# **Special Residential Development, Lyndon locations 222 and 223, Exmouth**

**Shire of Exmouth and Greenough Holdings Pty Ltd**

**Report and recommendations  
of the Environmental Protection Authority**

**Environmental Protection Authority  
Perth, Western Australia  
Bulletin 829  
August 1996**

Figure 2. Design of Subdivision.

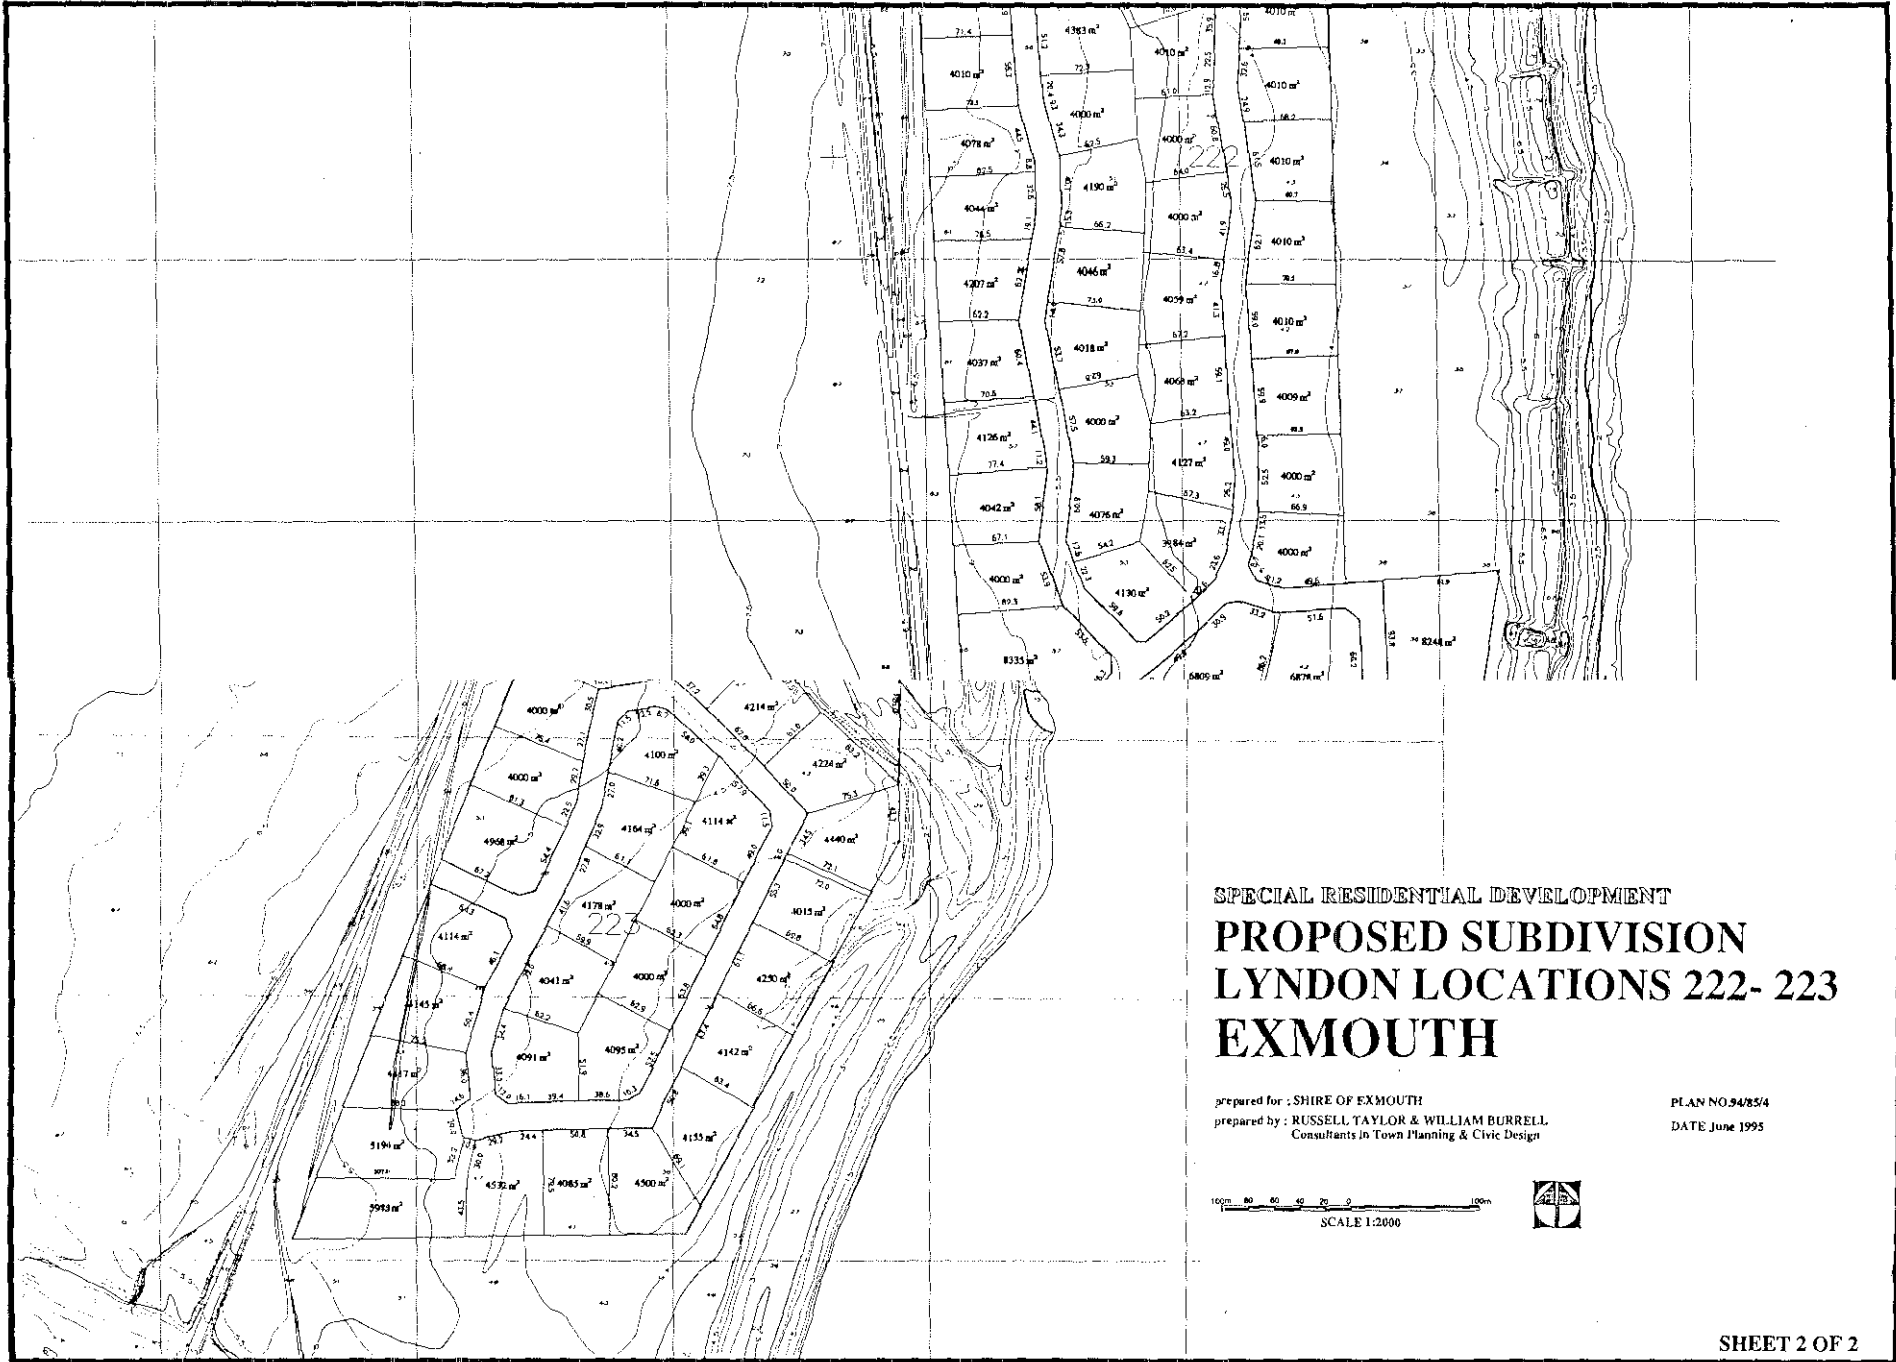
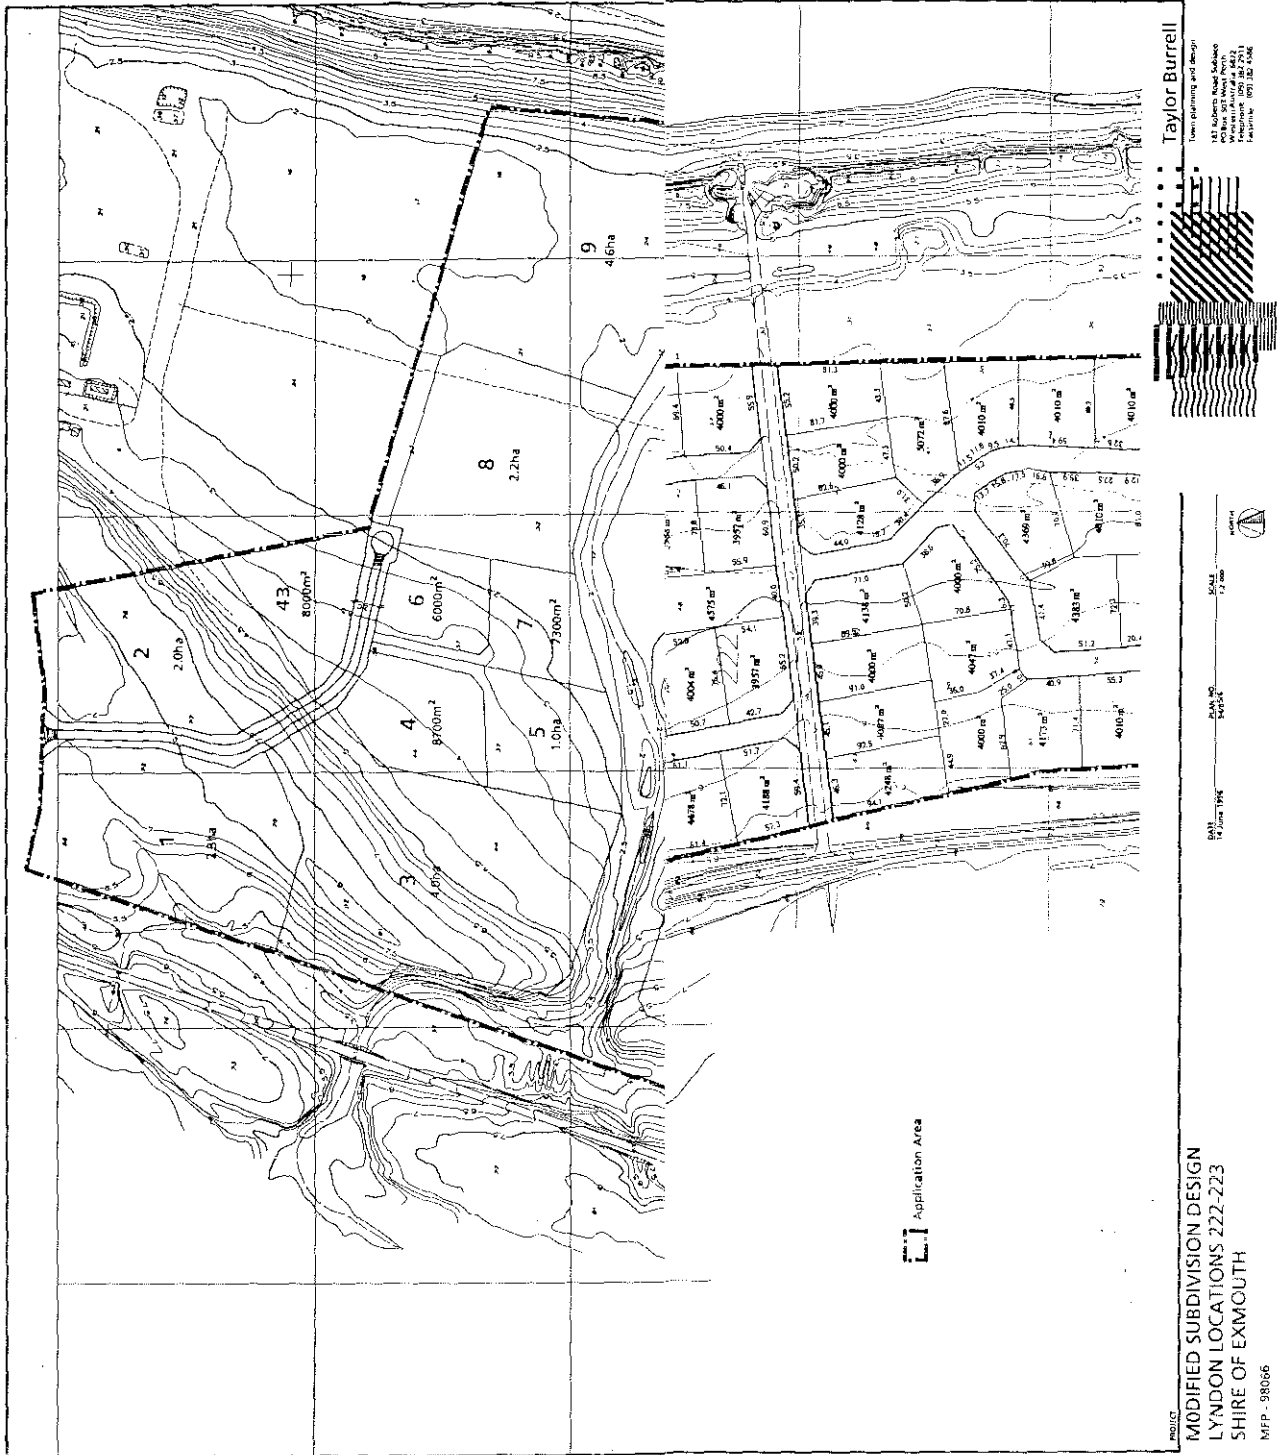
The special residential development proposed for this site is difficult to assess because the subdivision plan which was provided does not provide the level of detail required for assessment. A number of details of the proposal are therefore unclear.

**1. Foreshore reserve:** The precise placement of the reserve is not clear, although the Executive Summary at the beginning of the report states that "All of the precincts have a minimum setback distance of 100m from the high water mark". The Western Australian Planning Commission Policy No. DC 6.1 (the Country Coastal Planning Policy) determines that set backs of one hundred metres from the permanent vegetation line are to be used as a guideline for setbacks along sandy beaches, with variations according to the site's topography, geomorphology, climatic and oceanographic conditions. The position of the permanent vegetation line is not marked on the plan. Further work to justify the foreshore setbacks would be appropriate.

associated car parking facilities are depicted. The lack of a road along the western edge of the subdivision introduces additional access problems where lots abut the coastal reserve. This issue has not been adequately addressed. Additionally, access to the foreshore or to creek lines is provided at a number of points through apparent Right of Ways (ROW's) between lots. These provide additional access to the coastal foreshore and may result in localised dune erosion with subsequent management problems.

Figure 4. EPA recommendations for extensions to Cape Range National Park (1975).

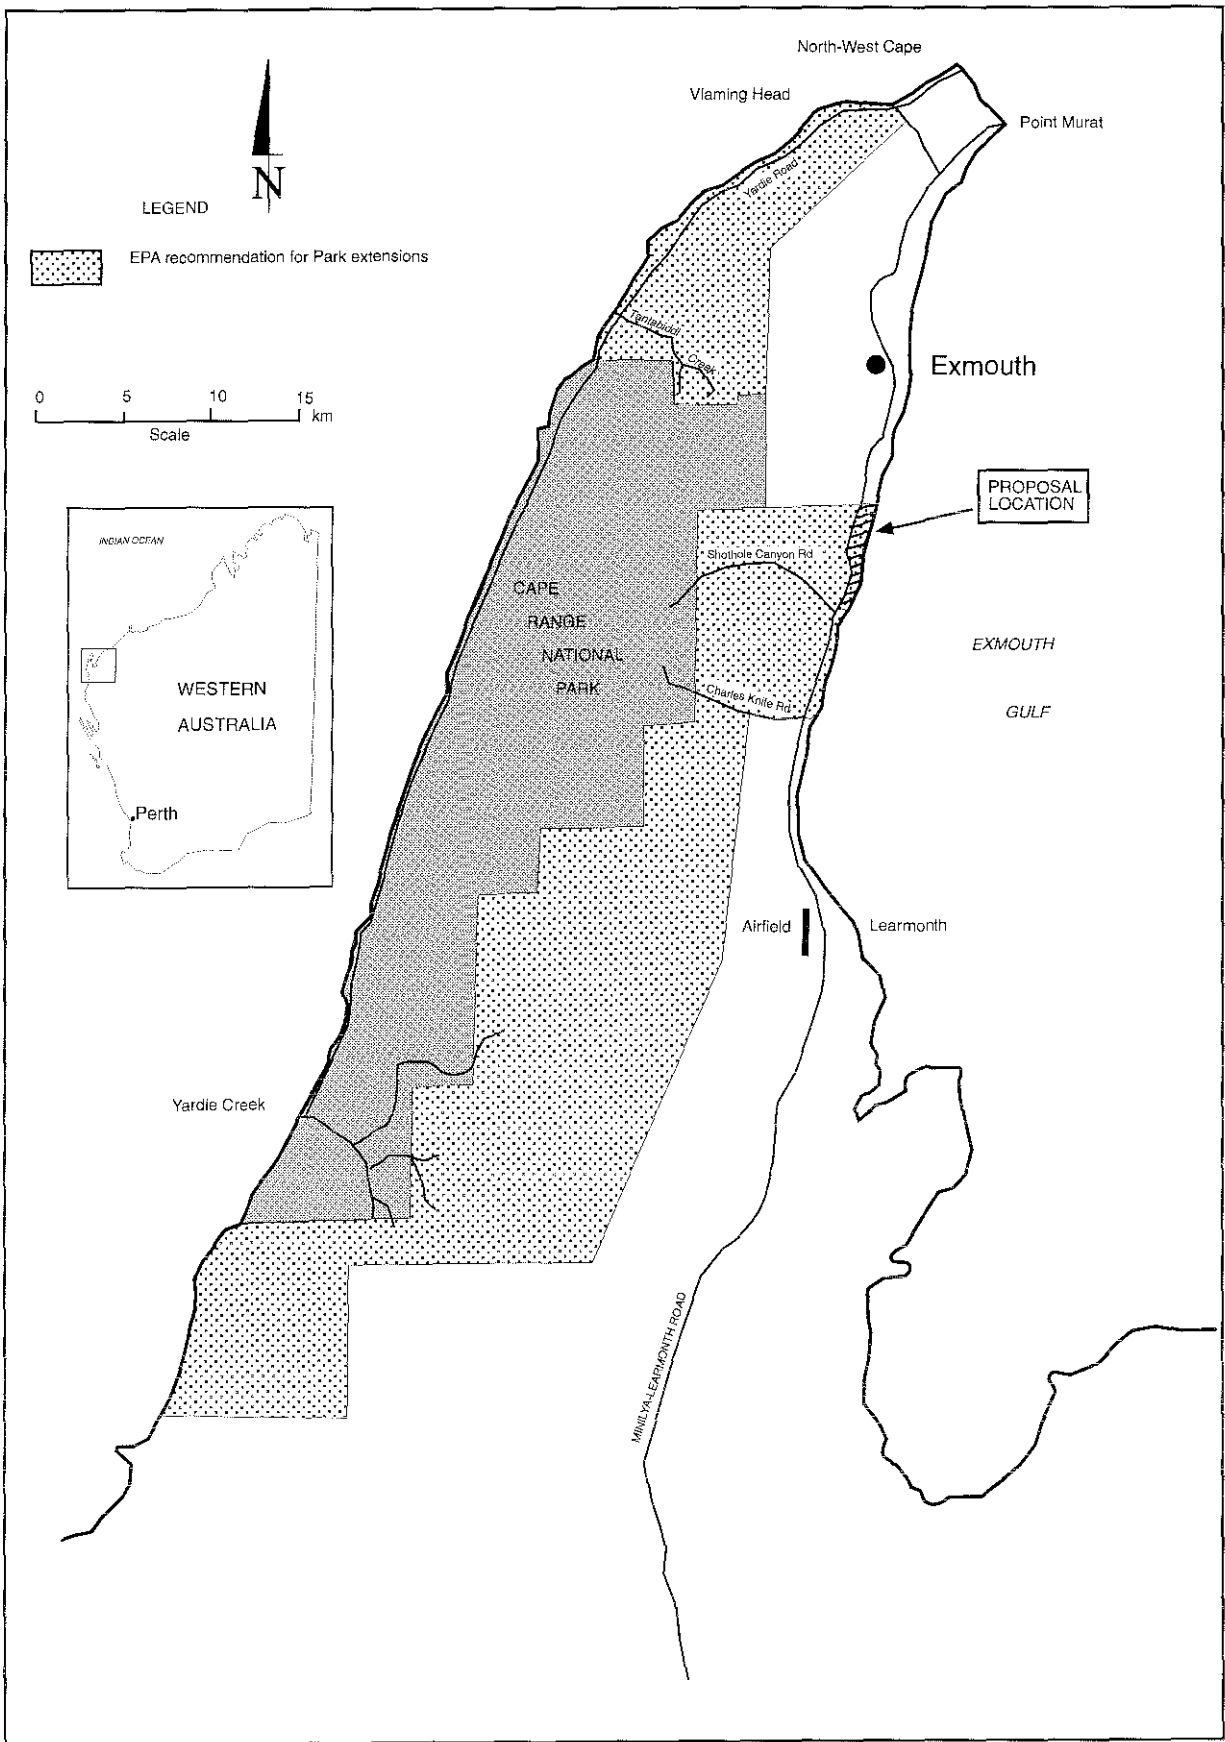
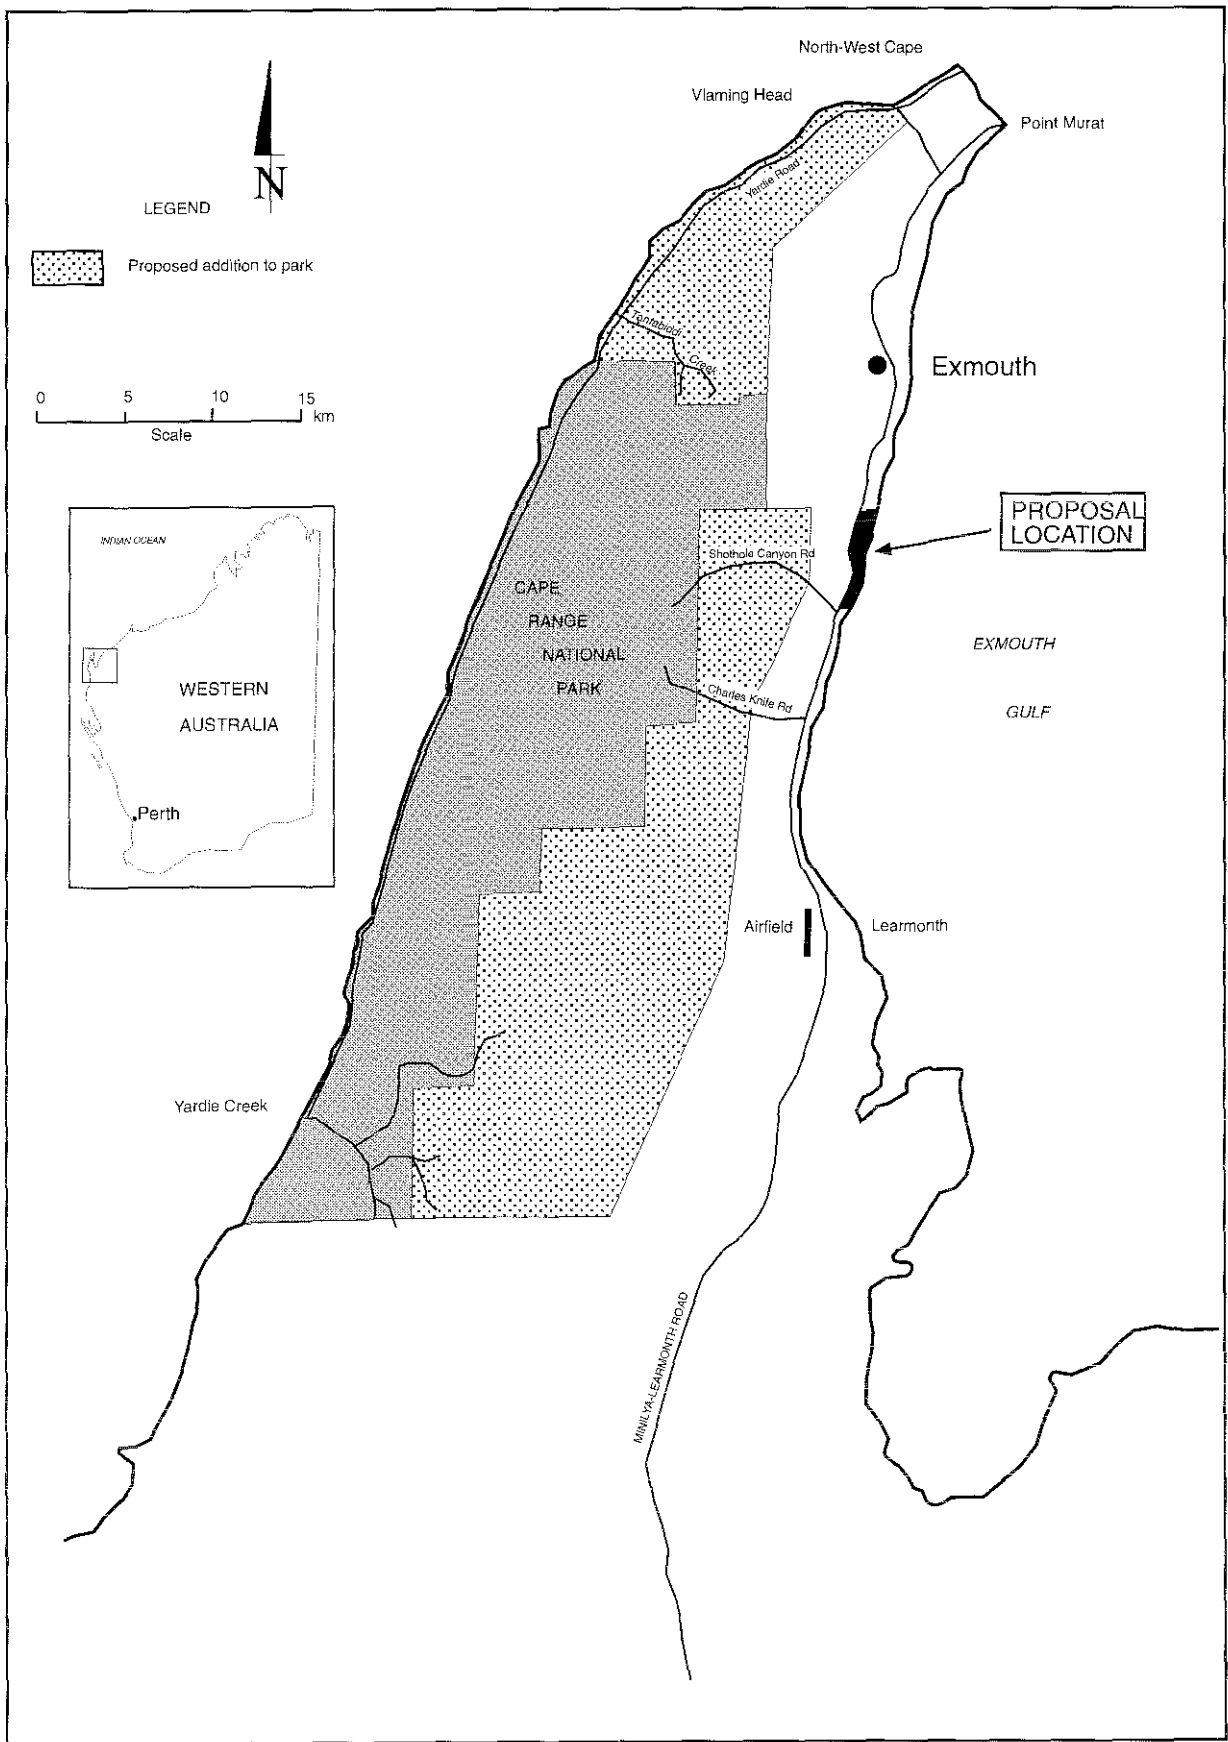
The proponents considered that it is unlikely that the eastern extension to the coast, as proposed by the EPA in 1975, would occur. It was stated that the extension to the park will most likely terminate at the base of Cape Range. If the extension proposed by the Department of Conservation and Land Management in the management plan (CALM, 1987) was implemented, the new park boundary would lie approximately 4 km to the west of the proposed subdivision.

The development of the land would reduce the possibility of proposed extensions to the Cape Range National Park, as proposed in the Cape Range National Park Management Plan. The aim of the extension is to provide another representative ecosystem and habitat type within the local conservation estate, and it has been suggested that a corridor extending to the shoreline of the Exmouth Gulf would be appropriate.

The EPA supports the concept of extending the National Park to provide a representative system of areas set aside for conservation, but considers that the site of the proposed subdivision need not be included in any extension.
